January 29, 2019

Re: Application No. SWG-2015-00110, Section 404 Clean Water Act Application of Annova LNG Common Infrastructure, LLC

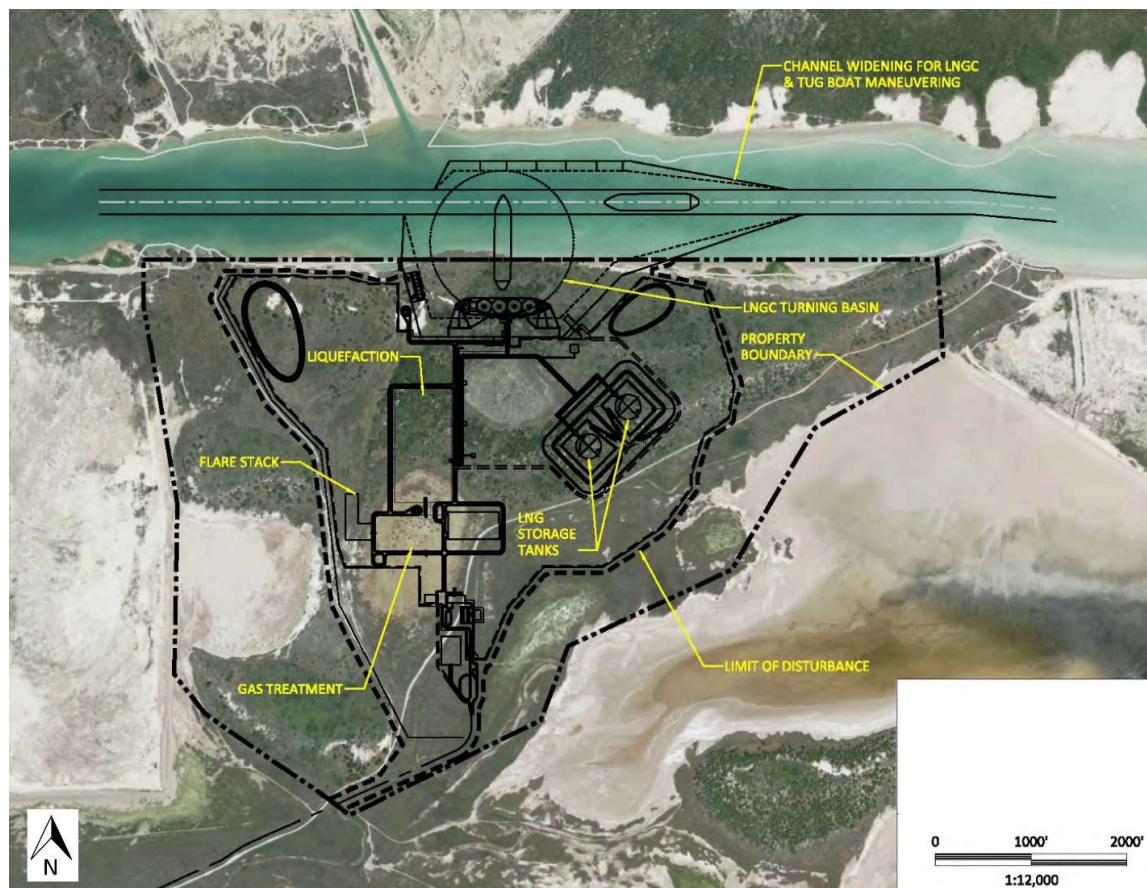
Here, Annova's primary permanent wetland impacts will be caused by pretreatment and storage, rather than marine transfer, facilities. Annova predicts that the project will permanently disturb 40 acres of wetlands, primarily "estaurine emergent". DEIS 4-29 to 4-300. The majority of these wetlands are at the terminal site, as shown in DEIS figures 4.4.2-1 reproduced below.

The proposed Annova facility design would fill these wetlands, as illustrated by DEIS figure 1-2, reproduced below (note the change in orientation):

In the proposed design, wetlands will be impacted by gas pretreatment facilities (which the Freeport project demonstrates can be located at a site miles away) and by liquefaction equipment (which Cove Point demonstrates can be a mile from marine loading facilities).

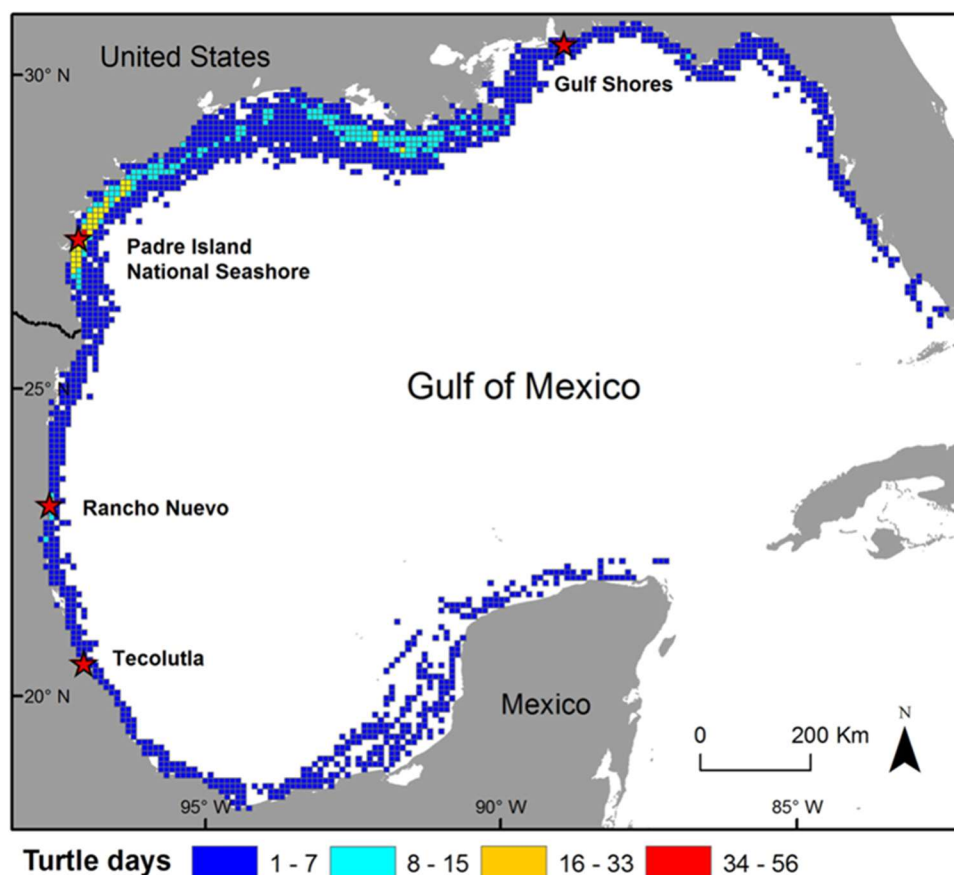
Turtles are known to be present in high density in this area, as shown in the map below, so many ship-turtle collisions are likely.³⁶ The Annova LNG terminal project and other LNG projects planned along the shipping channel will significantly increase the amount of ship traffic in the area, thereby increasing the probability of collision and turtle death. This may especially
